# UNITED STATES PATENT AND TRADEMARK OFFICE

APPLICATION NO.	FILING DATE	FIRST NAMED INVENTOR	ATTORNEY DOCKET NO.	CONFIRMATION NO.
10/008,766	11/07/2001	Robert H. Mimlitch III	50097-00003PT	9188
26231	7590	02/28/2006	EXAMINER	
FISH & RICHARDSON P.C. P.O. BOX 1022 MINNEAPOLIS, MN 55440-1022			FERGUSON, MICHAEL P	
			ART UNIT	PAPER NUMBER
			3679	
DATE MAILED: 02/28/2006

<b>Office Action Summary</b>	<b>Application No.</b>	<b>Applicant(s)</b>	
	10/008,766	MIMLITCH ET AL.	
	<b>Examiner</b>	<b>Art Unit</b>	
	Michael P. Ferguson	3679

1. In view of the supplemental appeal brief filed on November 21, 2005,  
PROSECUTION IS HEREBY REOPENED. New grounds of rejection are set forth  
below.

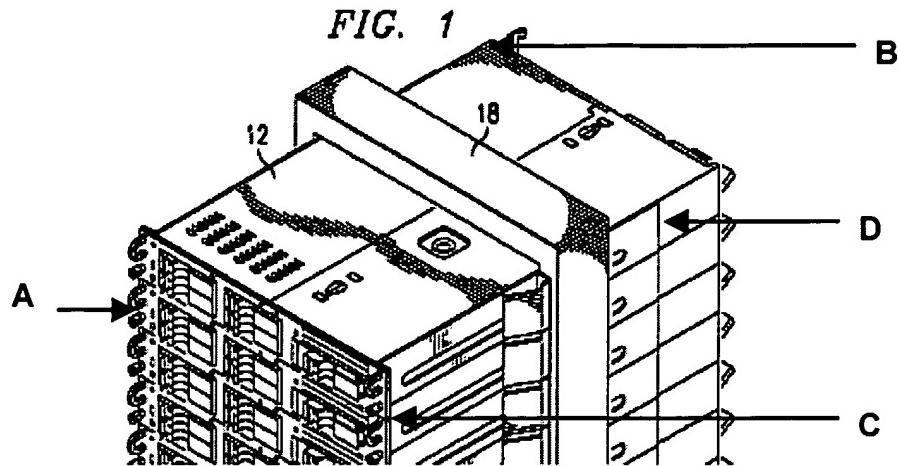
As to claim 52, Jensen et al. disclose a method for adapting a two-post equipment rack to support four-post loads, comprising:

coupling a first coupling member **20** to a first post **16**;

coupling a second coupling member **20** to a second post **16**;

coupling a third coupling member **20** to a first post **16** substantially planar to (the first and third coupling members lie within the same plane) and substantially parallel to a first coupling member **20**;

coupling a fourth coupling member **20** to a second post **16** substantially planar to (the second and fourth coupling members lie within the same plane) and substantially parallel to the second coupling member; and

wherein each of the coupling members emulate one respective post **A,B,C,D** (Figure 1 reprinted below with annotations) in a four-post rack, with each emulate post defining a supporting point for a load (via the hole in flange **30**; Figure 1).
